This Service Information bulletin replaces SI B16 08 18 dated October 2018

G12 (7 Series Sedan)	G30 (5 Series Sedan)	G32 (6 Series Gran Turismo)	
----------------------	----------------------	-----------------------------	--

SITUATION

The fuel delivery unit (in-tank fuel pump) may be the incorrect part installed for the Model/Market.

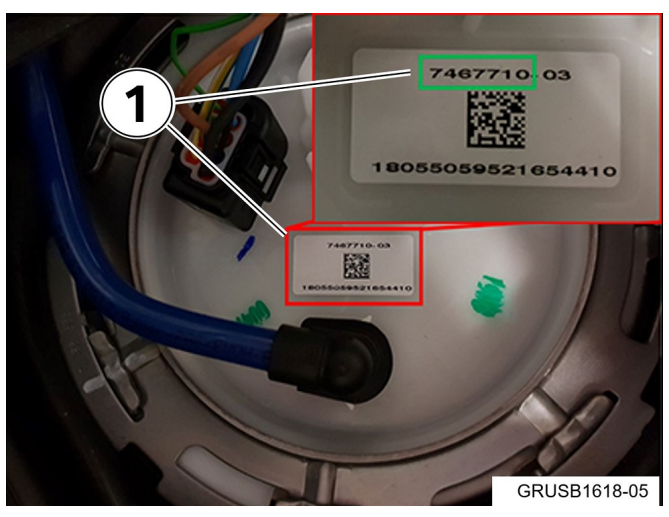
Check the part number of the fuel delivery unit (1). Compare the installed part number with the table below.

- If the part number matches any of the part numbers listed (for model/engine) no further repair is necessary.
- If the installed part number does not match the listed number in the table, the fuel delivery unit will need to be replaced. Continuing following the Repair Instruction 16 14 090 Removing and installing/replacing the delivery unit (without drawing off and filling fuel) to replace the fuel delivery unit.
